**RE: 60 Bay Ave Highlands LLC
Preliminary & Final Major Site Plan Approval
60 Bay Avenue
Block 42, Lot 1**

RE: **60 BAY AVENUE**
Response Letter (HLPB2024-02)
Block 42, Lot 1;
60 Bay Avenue
Borough of Highlands, Monmouth County, New Jersey

Review Letter, dated May 17, 2024

SHEET NO.: C300

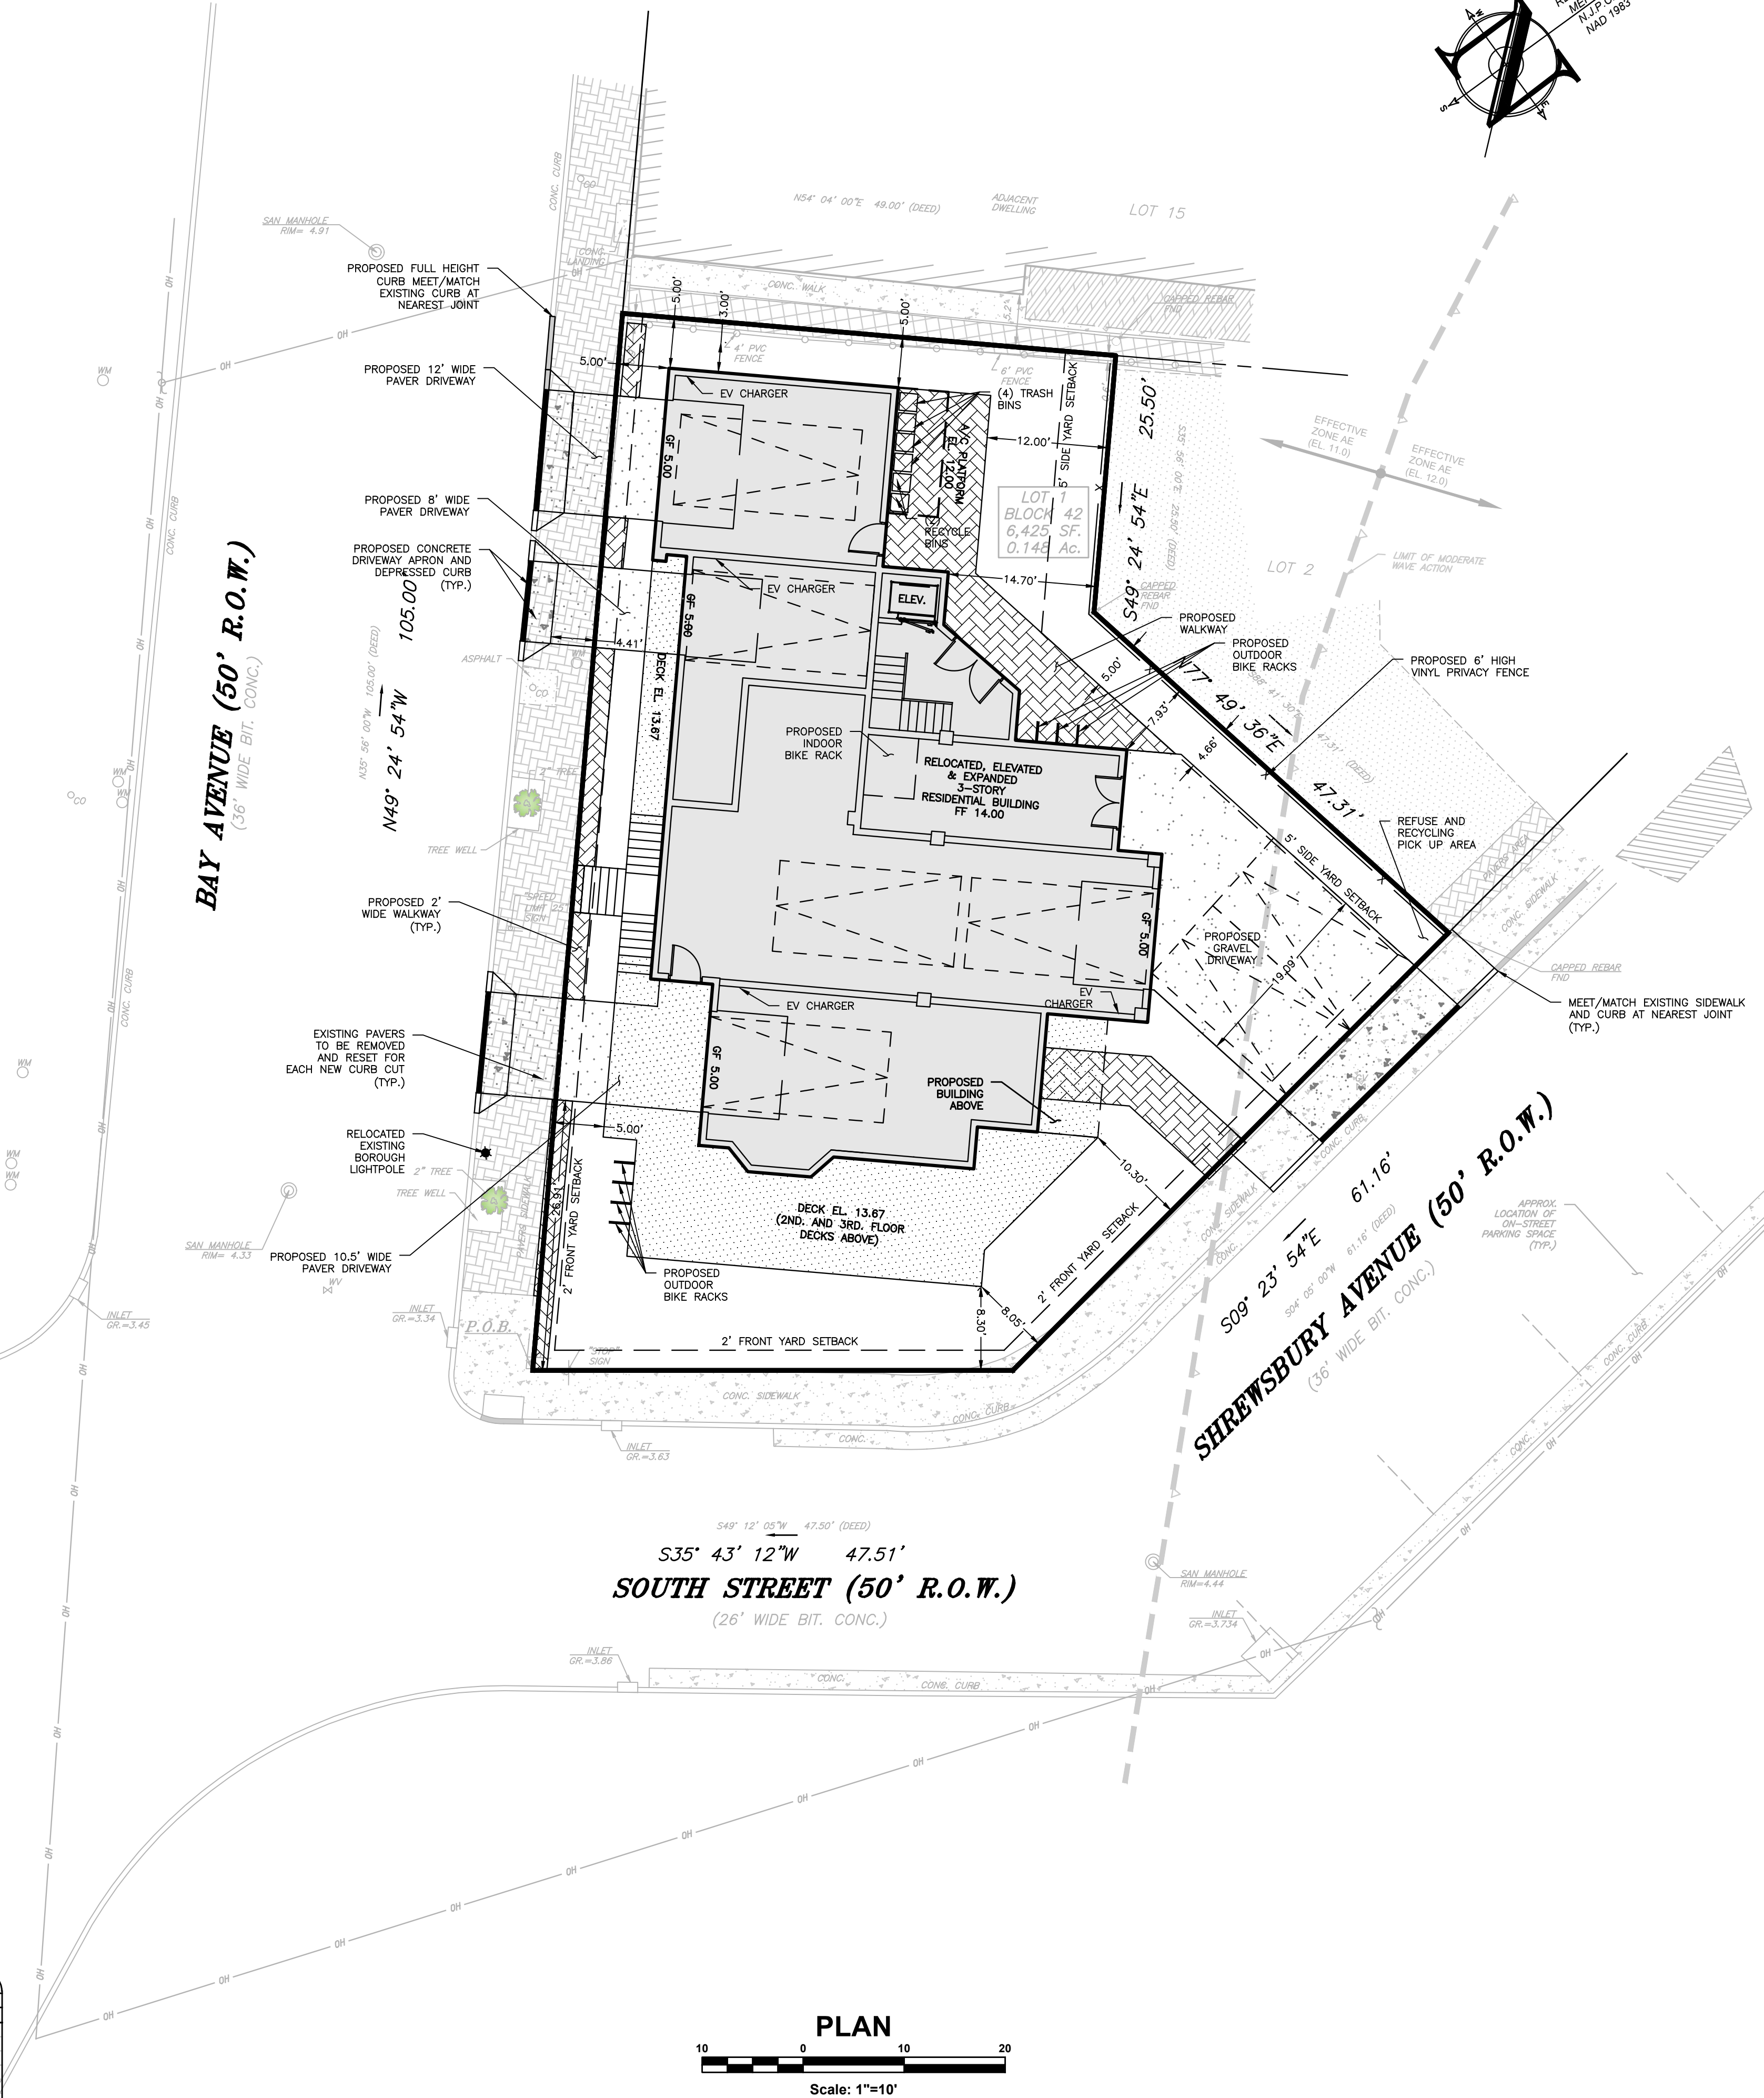
4. *Location, Use and ground floor area of all existing and proposed buildings, with the building setback, sideline, and rear yard distance. Partially provided.*

Provide ground floor area(s) on the site plans.

16. *The nature and location of public and private utilities, including maintenance and solid waste disposal, recycling and/or storage facilities. Partially provided.*

Provide location of recycling bins. Provide location of garbage disposal pick up.

4. *Please indicate on the plans the elevation and square footage of the floors and the required minimum outdoor living per 100 sf/unit plus 50 sf/BR. Please update the bulk requirements summary.*

29. *Please indicate where the recycling bins are to be placed.*

30. *Please indicate if there is a dedicated area for garbage and recycling pickup.*

A “Building Data” chart was added to the Site Layout Plan (C300).

The location of recycling bins and the location for garbage disposal pick up was added to the Site Layout Plan (C300).

The architectural plans as well as the Zoning Compliance Chart on the Site Layout Plan (C300) was revised accordingly.

The Site Layout Plan was revised (C300), accordingly.

The Site Layout Plan was revised (C300), accordingly.

**LIGHTING PLAN - EXISTING
CONDITIONS R.O.W. ONLY**

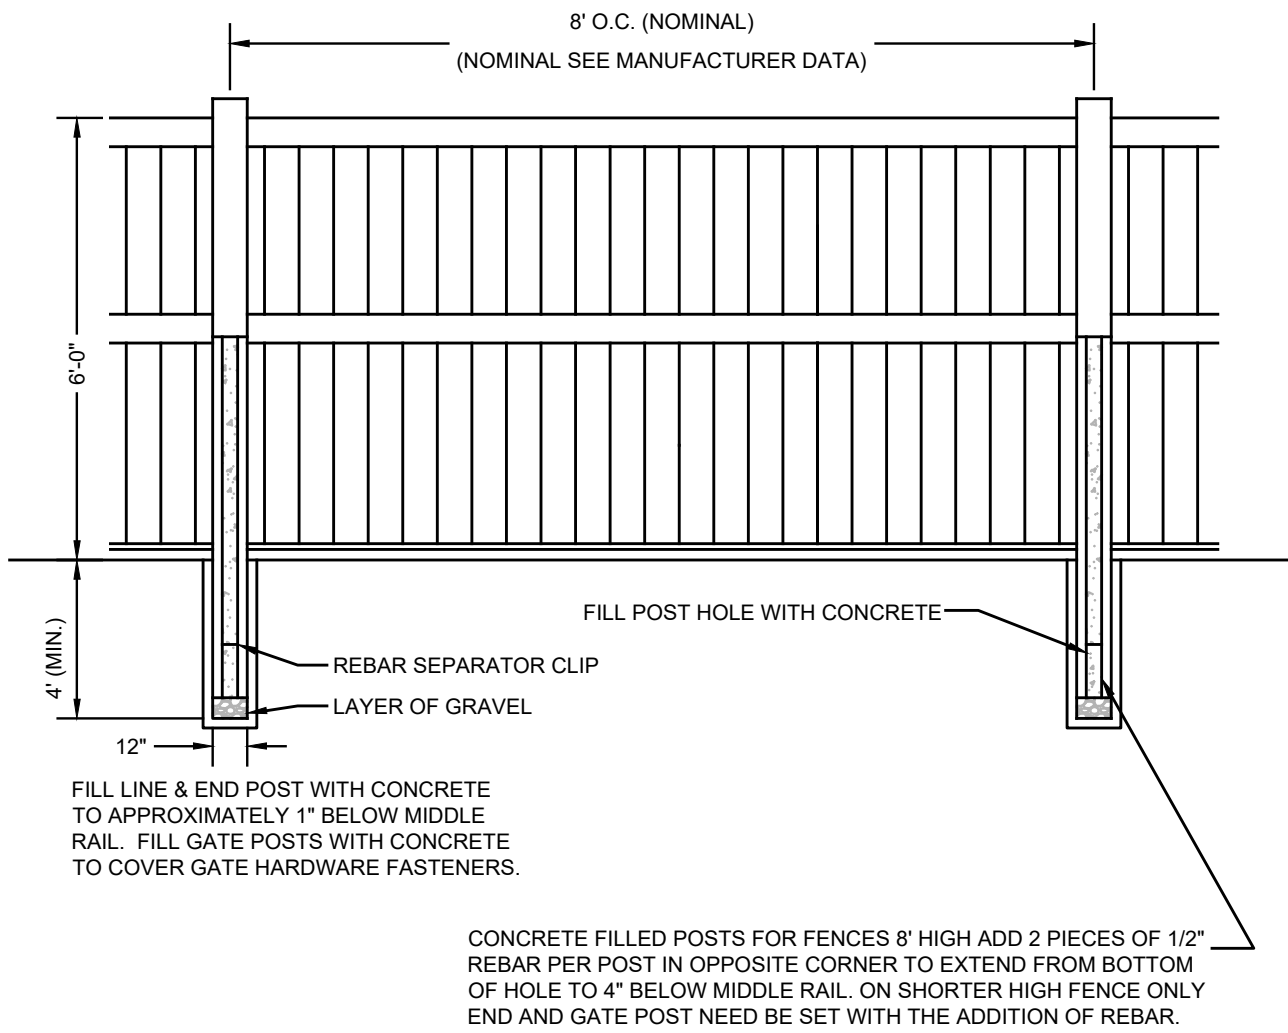
27. *The Application is requesting relief from 2 Lighting Ordinances:*
- a. Subsection 21-65(11)(E) Minimum Lighting Level. 0.3 fc is required, and 0.1 fc is proposed for the site.*
 - b. Subsection 21-65(11)(F) Maximum Lighting Level at property line. 0.3 fc is permitted, and 1.7 fc is proposed for the site.*

The Applicant did not include existing lighting in the analysis.

The existing decorative streetlight (see comment above) and street lighting need to be included for an overall analysis.

It is unknown if the existing fencing along Lot 15 has factored into the analysis. The proposed light facing Lot 15 does not seem to have the same intensity as those of the other proposed lights.

There is a lighting void area for the main entrance and sidewalk to the proposed building along Bay Avenue. Please provide sufficient lighting for the entrance and sidewalk.

Please provide the manufacturer's specifications.

We recommend the applicant provide the minimum lighting level required, and a decrease in lighting levels at the property line, along with testimony of why such highlighting levels are being requested.

The existing fence along Lot 15 was factored into the analysis. Manufacturers specifications were added to the plans. Existing lighting from the ROW was added to the plan first in a standalone viewport, and secondly it was included in the proposed lighting conditions.

ROOF LEADER COLLECTION SYSTEM
CAPACITY CALCULATIONS

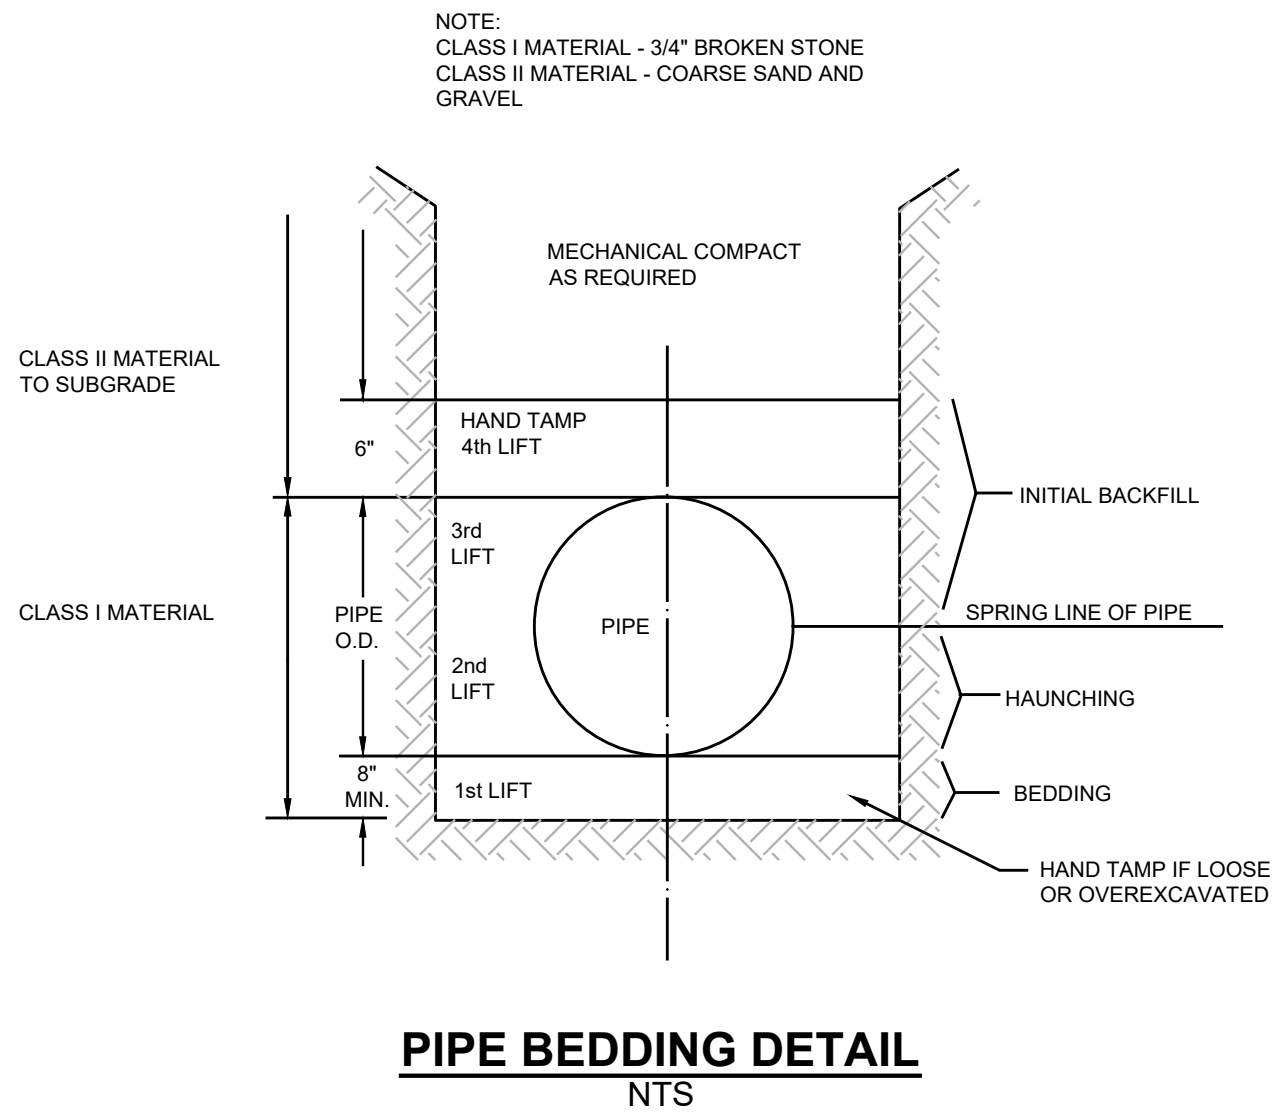
19. *Indicate inverts, cleanouts, roof leader connections and splash blocks on the plans for the roof leader collection system that discharges to an existing inlet located on South Street. Provide size and material type on the plans.*

Proposed downspout locations were added, accordingly. The “Exterior Downspout Collector” detail indicates that a splash block is proposed at each downspout location. Size, material, and slope of pipe is indicated on the plans with capacity calculations.
